Delegated officer report for planning application

Application no.	144062/LO/2025	
Date registered valid:	6 January 2026	
Proposal:	Listed Building Consent for the installation of signage, internal and external alterations and associated works.	
Address:	Atlas Chambers, Ship Canal House, 96 - 98 King Street, Manchester, M2 4WU	
Ward(s):	Deansgate	Ward
Applicant:	Costa Ltd	
Agent (if any):	Miss Anisha Ahmed Savills	
Case officer:	Sam Tel: 0161 219 Email: sam.elliott@manchester.gov.uk	Elliott 2856
Recommendation:	Refuse	
Date of recommendation:	12/02/2026

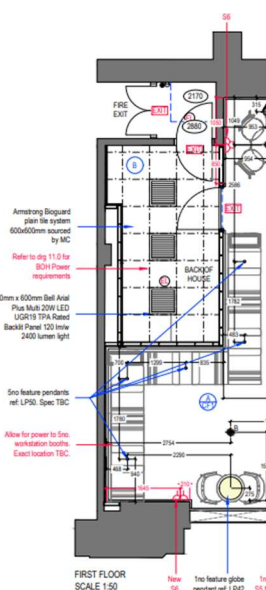
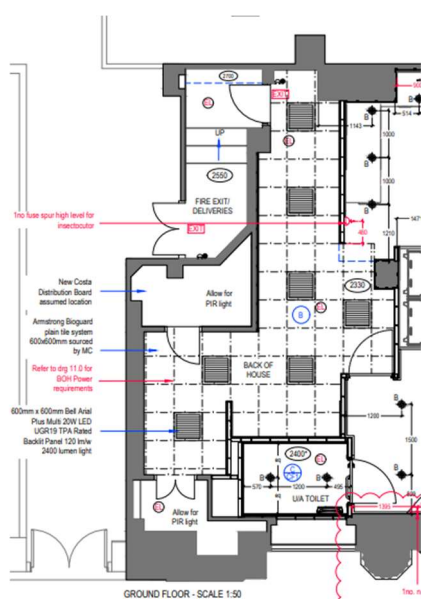
The demolition plans indicate that in the strip out all existing lining would be removed from the column at ground and first floor, reducing boxing 'to a minimum'. No account has been provided of what architectural features of the building constitute its remaining historic fabric, and it is unclear whether this column proposed to be exposed is of historic significance.

Mention is made of the removal of secondary glazing in the Planning, Heritage, Design and Access Statement, though it is not clear from the drawings where secondary glazing would be removed.

An existing ceiling plan has not been provided, and it is unclear to what extent the ceilings are impacted by the strip out works.

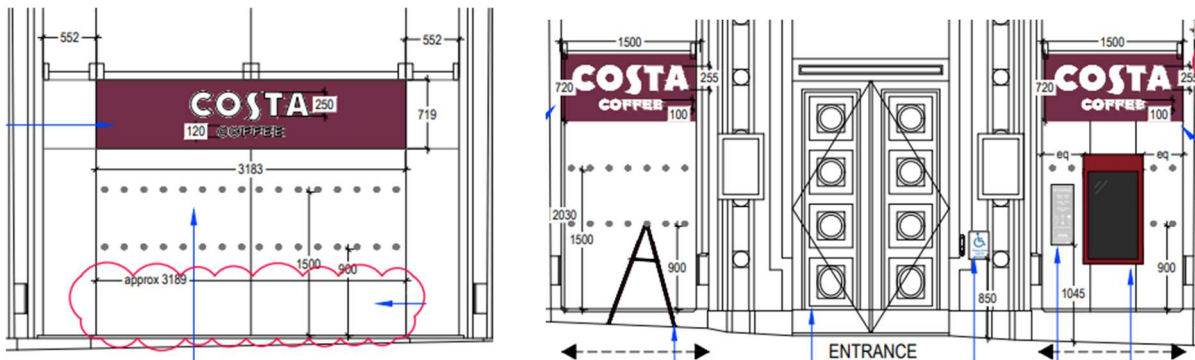
There would also be an internal double sided LED advertisement screen affixed to the rear side of the glazing adjacent to the bronze door.

It is noted that large sections of internal vinyl have been removed from the scheme as per the amended drawings submitted 11/02/2026.

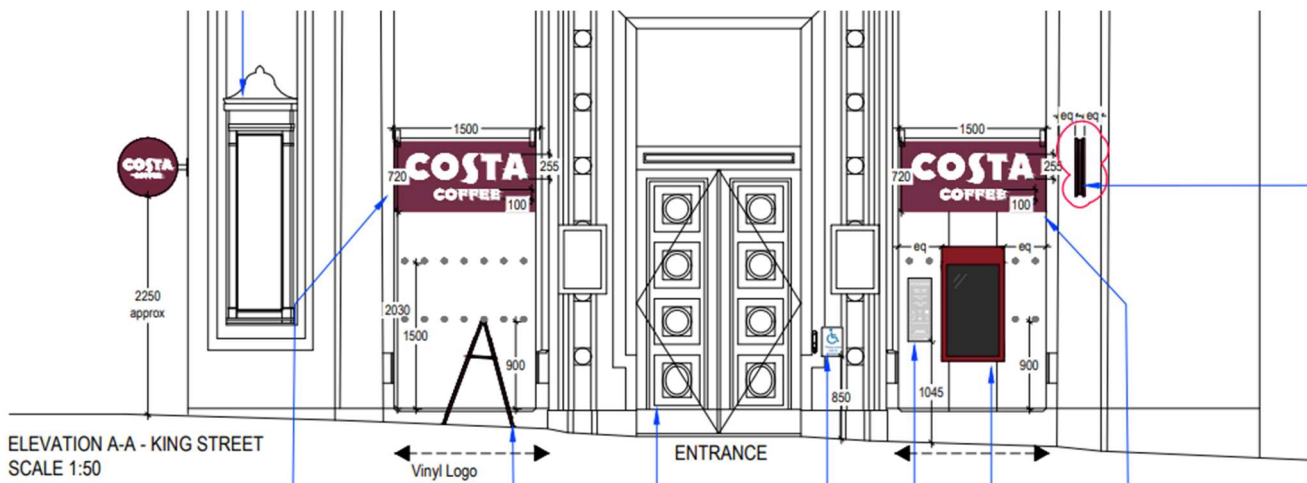
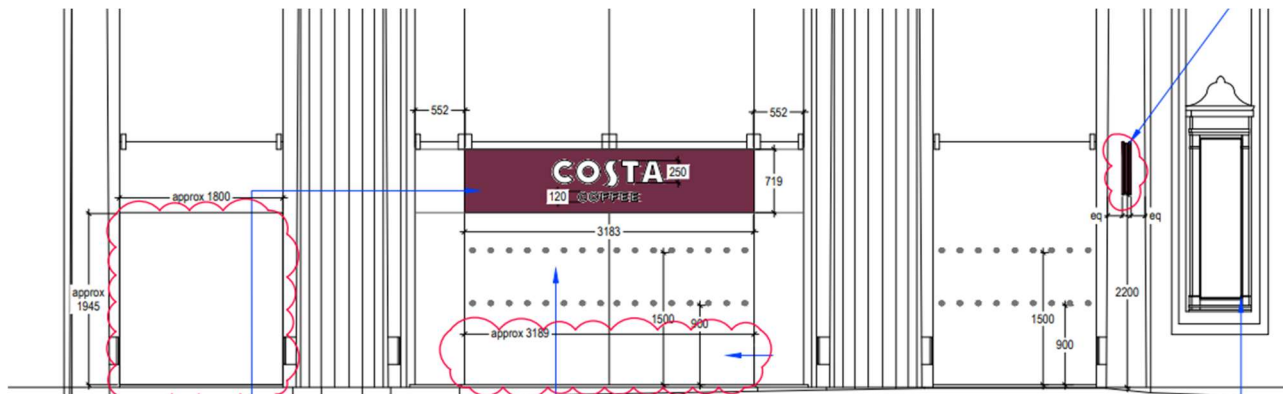
Details of the height of the King Street projecting sign to the right side of the brass door have not been included, however based on previous drawings it would be sited approximately 2500mm from external floor level. The Brown Street projecting sign would be sited approximately 2250mm from external floor level and in proximity to the bronze corner plaque.

The projecting signs would be circular 'lollipop' signs with a diameter of 600mm and a depth of 95mm. They would have a support arm, and while the amended plans do not include this information, it is assumed based on the submission of earlier plans that the support arm would extend 150mm of the external face of the elevation, with an approximate total projection of 750mm. They would have acrylic faces and be internally illuminated with illuminance levels of 600cd/m² to exhibit the 'Costa Coffee' branding in white text with a 6500k cool white lighting through an opal acrylic face, and have a maroon background. Their sides would feature 2no. coral vinyl bands.

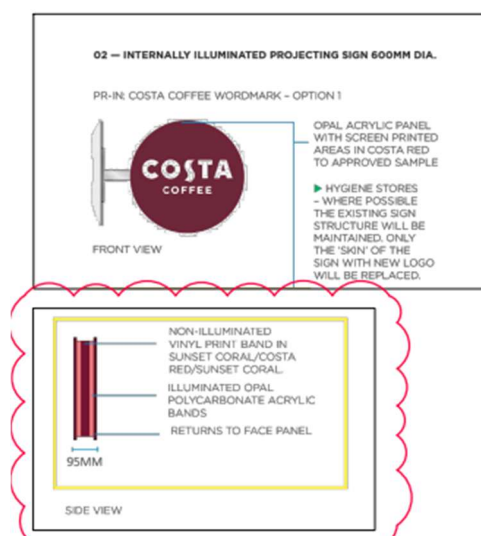
The amended drawings have omitted fixing details previously provided, and it is assumed that the signs would be fixed via RAWL bolts through a base plate with a stainless-steel shroud as previously indicated. No details have been provided regarding the size of the baseplate which would help affix the signage to the stonework.

The amended drawings make reference to a number of additional vinyl elements, including the placement of a sticker on the building's bronze door, an opening times sticker, and signage to the central section of the bronze plaque. Few details of these elements have been provided. A bell is also shown on the building's bronze door.

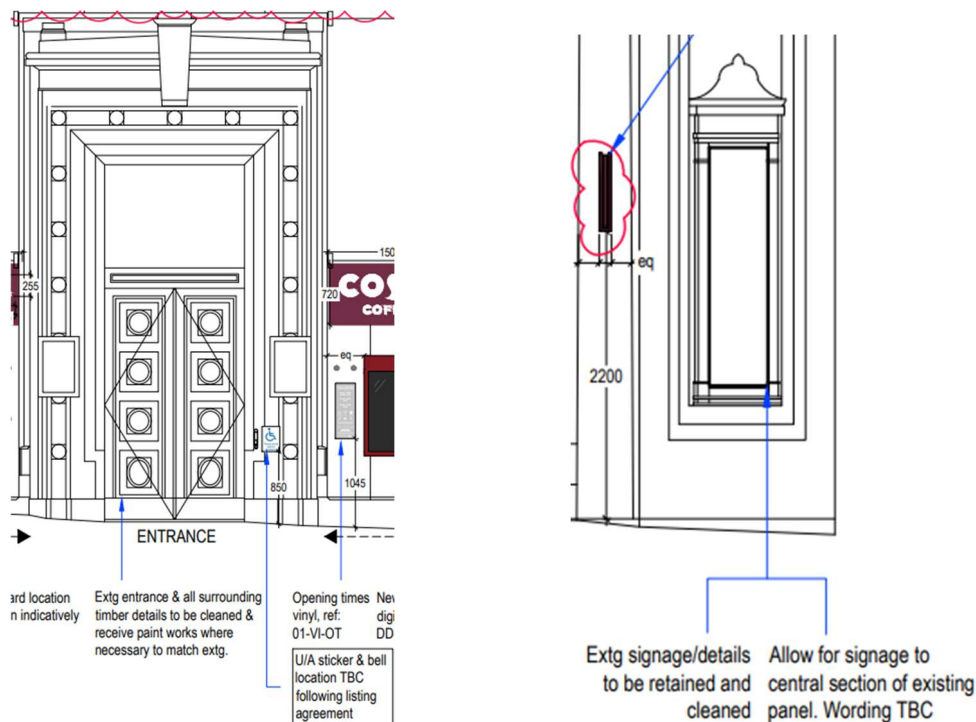
The proposed elevations show a bell to be affixed to the bronze door, and annotations indicating cleaning to the bronze panel and stone columns. No fixing or cleaning details have been provided.

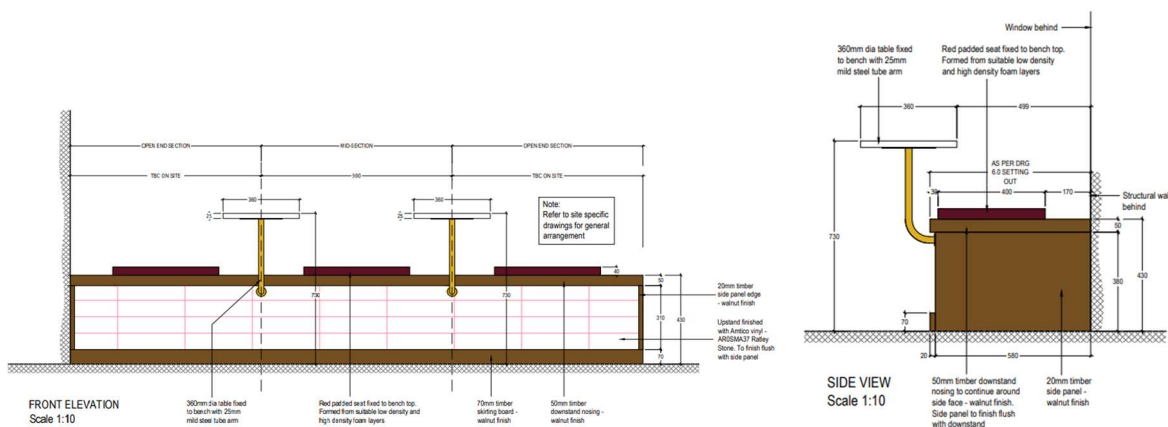
However, it is noted that the amended plans have retained seating arrangements at ground floor within the glazed windows shown previously, but have now specified that they will be freestanding.

While it is acknowledged that the above would be reversible, these elements would impact the permeability of the glazing and be seen together with the building's masonry and bronze work which comprise its most significant historic fabric.

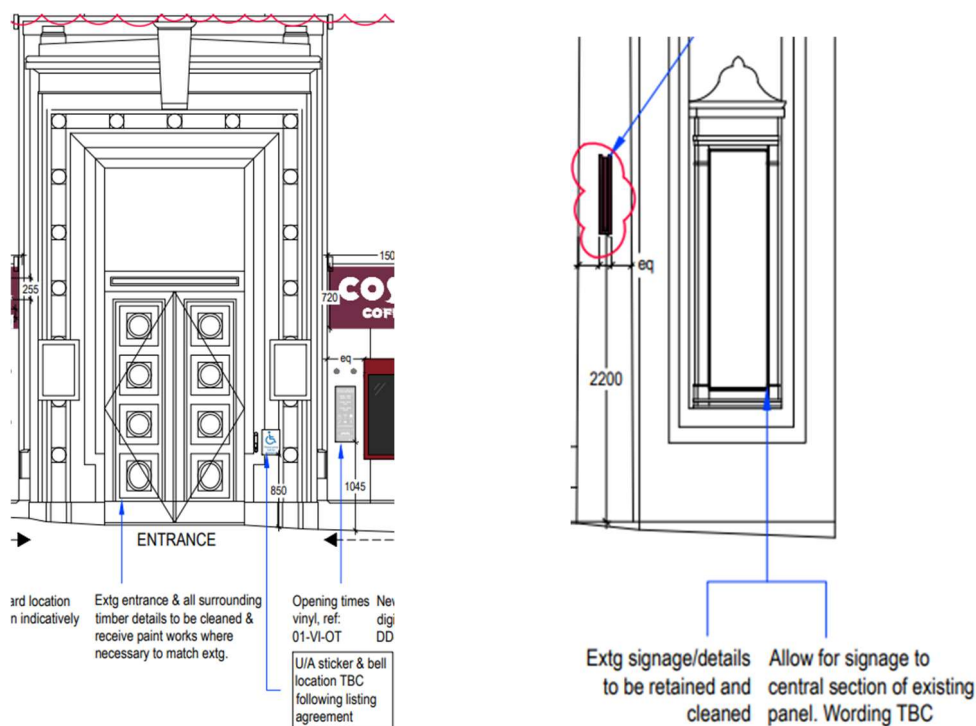
The amended drawings make reference to a number of additional vinyl elements, including the placement of a sticker on the building's bronze door and signage to the central section of the bronze plaque. While few details of these elements have been provided, these elements are strongly resisted by the Council and would view them as incurring significant harm to the remaining historic fabric of the building.

Ultimately, it is considered that both individually and when taken together the proposed signage strategy for the unit would appear low-quality, fragmented and overly cluttered, creating a cluster of disparate and modern acrylic, aluminium and LED signage elements which pose a significant level of harm to the building's significance.
